From: HUTCHINS, Steven [sph@nei.org]
Sent: Tuesday, September 08, 2009 11:16 AM
To: Frumkin, Daniel
Cc: Weerakkody, Sunil; Klein, Alex
Subject: Proposes changes to NEI 00-01 R2 Section 3.5.1 and Appendix E to address NRC Comments
Attachments: NEI 00-01 R2 Revised Circuit Failure Criteria post ACRS Mtg.pdf; Appendix E - Proposed Change to Rev 2.pdf

Dan. In an effort to resolve the remaining differences between NEI 00-01, Rev.2 and RG 1.189, R2, here are some changes NEI will be making to NEI 00-01, Rev.2. If agreed, we will issue an addendum to the NEI document, so the revision number will not change.

3.5.1 CRITERIA/ASSUMPTIONS

APPENDIX E

The figure below depicts this definition of time zero.

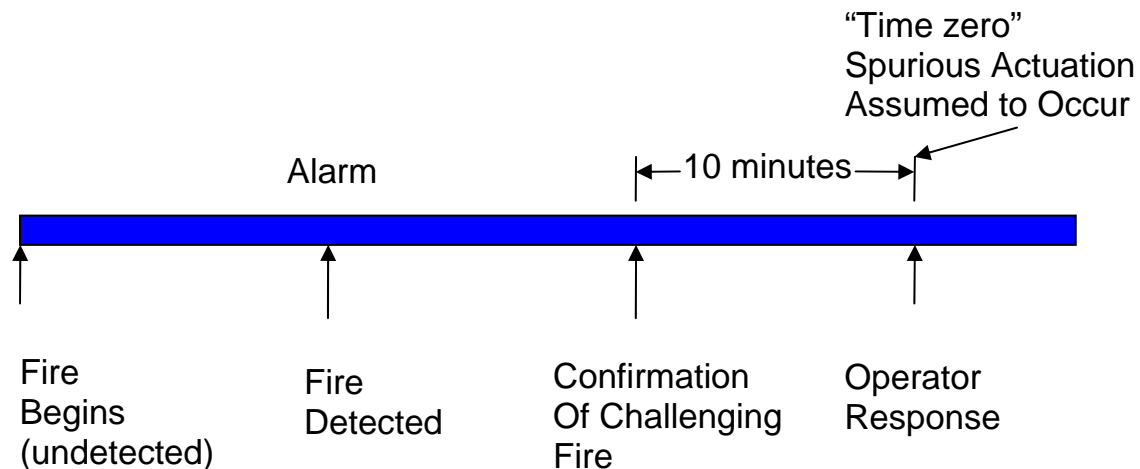
Based on this, time zero is specified to 10 minutes after the confirmation by plant personnel that the unit is experiencing a challenging fire. Indication of the fact that the fire being experienced is challenging is based on observations by plant operations

personnel that results in the need to scram the unit, ~~and to close the MSIVs~~. Coupled with this assumption of a unit scram, assuming closure of the MSIVs (for BWRs) is a necessary assumption to provide boundary conditions on any analysis performed to determine the amount of time available prior to impacting safe shutdown. Assuming closure of the MSIVs (for BWRs) is a conservative assumption since many events will result in an MSIV closure. A fire induced loss of offsite power will result in a closure of the MSIVs (for BWRs). Additionally, the availability of multiple support systems, e.g. instrument air, is required to keep the MSIVs open (for BWRs). Finally, there are multiple automatic closure signals that will result in closure of the MSIVs (for BWRs). These closure signals could be simulated by fire-induced circuit failures.

Based on this ~~definition~~, unit scram and MSIV closure (for BWRs) may also be used as initial conditions applicable to any analysis assessing plant impacts as a result of fire-induced damage.

Linking confirmation of a challenging active fire ~~and allowing a to the beginning of the~~ 10 minute time frame for operator recognition and response before any fire-induced failures, including spurious equipment operations, occur is not only consistent with the current licensing basis, it is also consistent with the practical implementation of any safe shutdown strategy requiring operator initiation of plant safety systems. In actuality, if a
